Project	IEEE 802.16 Broadband Wireless Access Working Group < http://ieee802.org/16 >	
Title	Object_id Definitions for Service Primitives	
Date Submitted	2006-11-10	
Source(s)	Joey Chou Intel Corporation	[mailto:joey.chou@intel.com]
	Guo Qiang, Wang, Michael Wang Nortel	[mailto:guoqiang@nortel.com] [mailto:chungw@nortel.com]
Re:		
Abstract	This contribution proposes the Object_id definitions to be used in service primitives for identifying NCMS, BS, or MS entities.	
Purpose	Adoption	
Notice	This document has been prepared to assist IEEE 802.16. It is offered as a basis for discussion and is not binding on the contributing individual(s) or organization(s). The material in this document is subject to change in form and content after further study. The contributor(s) reserve(s) the right to add, amend or withdraw material contained herein.	
Release	The contributor grants a free, irrevocable license to the IEEE to incorporate material contained in this contribution, and any modifications thereof, in the creation of an IEEE Standards publication; to copyright in the IEEE's name any IEEE Standards publication even though it may include portions of this contribution; and at the IEEE's sol

Figure 470—Object_id Tree Structure

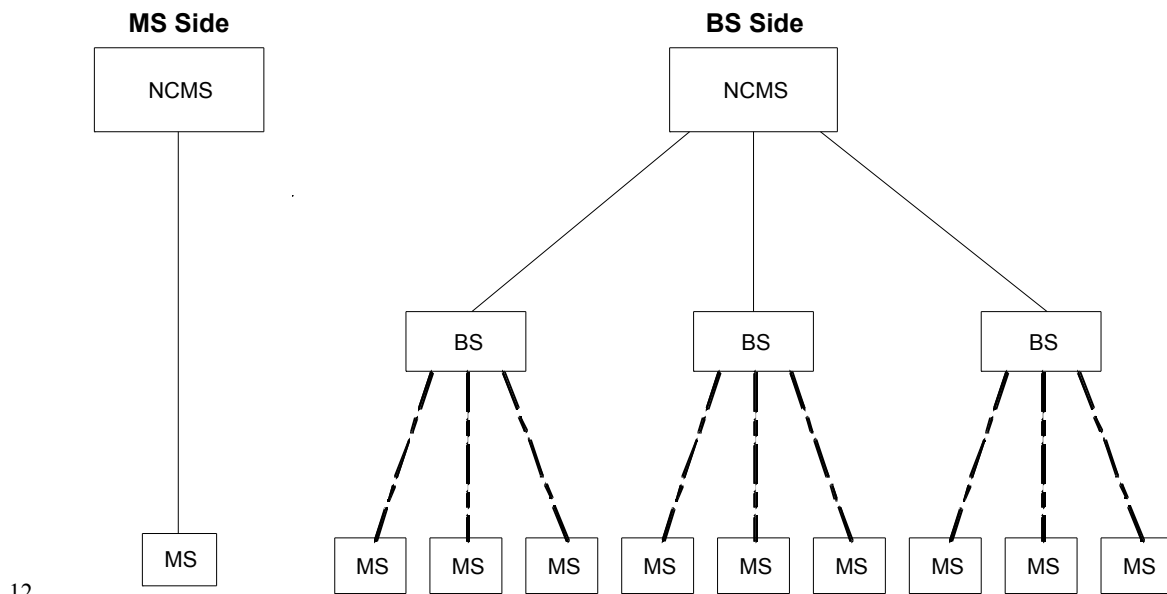
6 [Insert the following text to the end of subclause 14.1.2:]

9 Figure 470 depicts the Object_id tree structure for the 802.16 Network Reference Model as shown
10 in Figure 1b. At the BS side, a NCMS can manage multiple BSs. At the MS side, the NCMS can
11 manage only one MS.
